# Access Compliance Report

Intersection ID: 28212	Main Street: CHASEWATER_DR	Cross Street: DARBY_CHASE_DR	Location: S
ADA ID: B5F8FC72C2C6	Ramp Type: Perp	Initial Pass/Fail: Fail	Overall Compliance: No
			Severity Score: 1.25

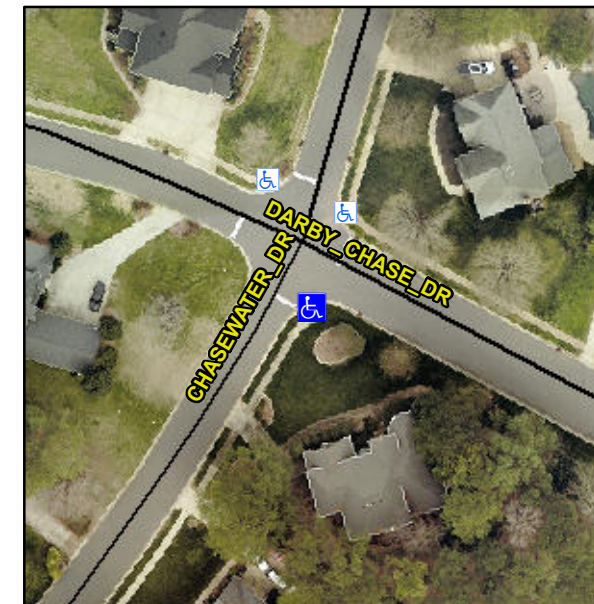
**Not Found, R304.5.3**

Compliance	Description	Data	Compliance	Description	Data
N/A	Ramp Length (in)	48.0	Yes	Ramp Slope (%)	5.1
Yes	Ramp Width (in)	48.0	No	Ramp XSlope (%)	3.6
N/A	Flare Type LT	N/A	N/A	Flare Type RT	N/A
N/A	Flare Slope LT (%)	N/A	N/A	Flare Slope RT (%)	N/A
N/A	Flare Traversable LT?	N/A	N/A	Flare Traversable RT?	N/A
N/A	Landing Length (in)	N/A	N/A	DWS Provided?	N/A
N/A	Landing Width (in)	N/A	N/A	DWS Contrast?	N/A
N/A	Landing Slope (%)	N/A	N/A	DWS Length (in)	N/A
N/A	Landing X Slope (%)	N/A	N/A	DWS Full Width?	N/A
N/A	Landing Curb? (Y/N)	N/A	N/A	DWS Offset (in)	N/A
N/A	Shared Landing?	N/A			
N/A	Gutter Ponding?	N/A	N/A	Gutter Slope (%)	N/A
N/A	Gutter Lip Ht (in)	N/A	N/A	Gutter X Slope (%)	N/A
N/A	Painted X Walk1?	No	N/A	Painted X Walk2?	N/A
	X Walk 1 Direction	To NE		X Walk 2 Direction	N/A
N/A	X Walk 1 Width (in)	N/A	N/A	X Walk 2 Width (in)	N/A
	X Walk 1 Slope (%)	4.2		X Walk 2 Slope (%)	N/A
	X Walk 1 X Slope (%)	0.5		X Walk 2 X Slope (%)	N/A

**Remove & Replace Entire Ramp.**
